DESIGN REVIEW RECOMMENDATION

ADMINISTRATIVE DESIGN REVIEW

SDCI # 3036520-LU
325 NW 85th St
Seattle, WA 98117

WEST WINDOW WELL

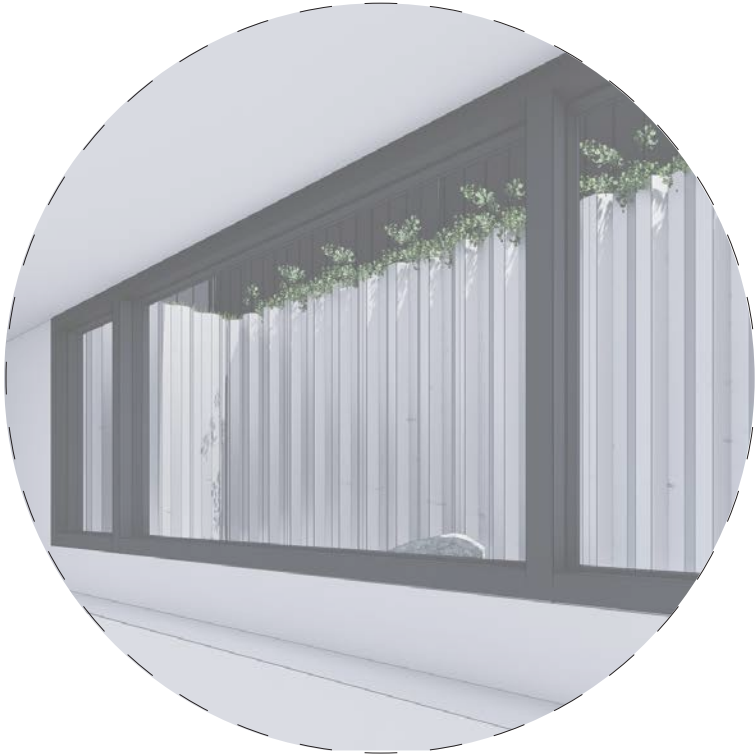
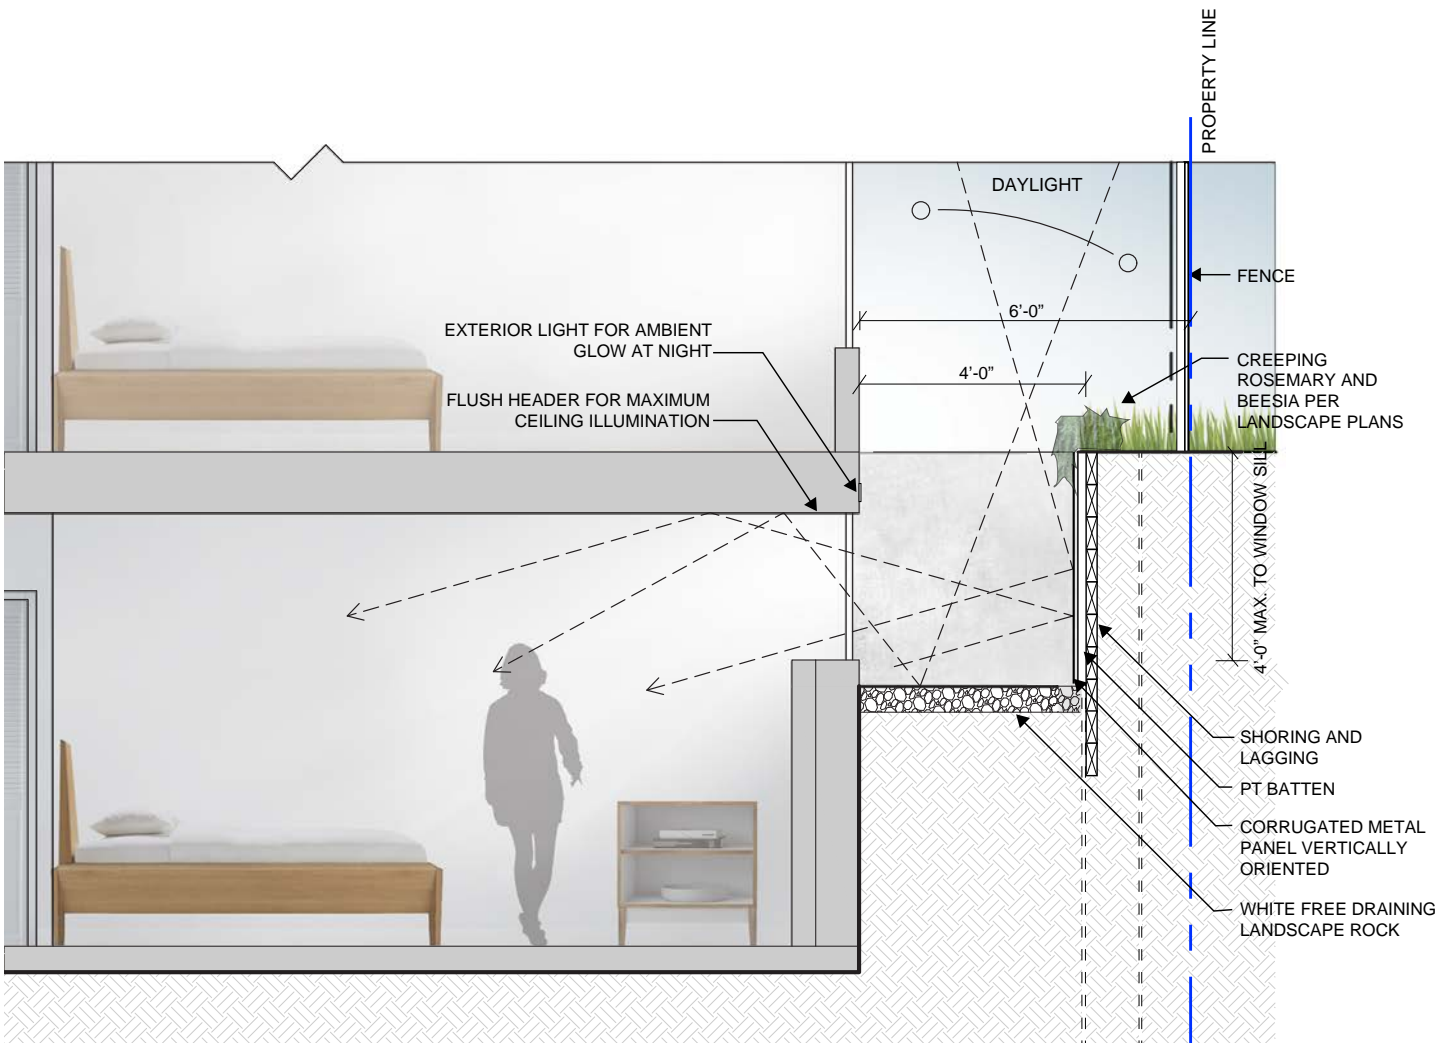
3. G. Staff appreciates the information provided in the packet on the light wells that are proposed along east and west property lines but is concerned that the exterior precedent design concept image does not match the proposed condition. Demonstrate how the proposed condition allows natural light and includes tiered landscaping. If necessary, increase the lightwell by moving the wall closer to the property line.

APPLICANT RESPONSE:
The design of the light wells has evolved from the concept presented at EDG after consultations with the geotechnical and structural engineers. The window sills remain located 4'-0" from grade. While a code requirement, it also ensures the light wells are relatively shallow to allow natural light to penetrate and reflect into the units. Each unit is provided with a 8' wide window with a flush header, which is approximately 75% of the unit width. The flush header is utilized for maximum ceiling illumination. The windows are also operable for a connection to the exterior and entrance of fresh air into the unit.

The window well itself is 4'-0 wide and clad in a white corrugated metal panel, with the corrugations vertically oriented. The white metal will reflect light within the well, bouncing it into the unit. The corrugations will maximize the reflection in all directions while providing an attractive, textural material to view from inside the unit. White landscape rock located at the bottom of the well also provides an attractive, natural element while additionally helping to reflect the light. Creeping rosemary and breesia will further enhance the light well with greenery, flowers and a subtle, pleasing scent.

At night the occupants have the option to illuminate the light well with a light above their window. The down light will reflect off the landscape rock and metal panel to create an ambient within the unit.
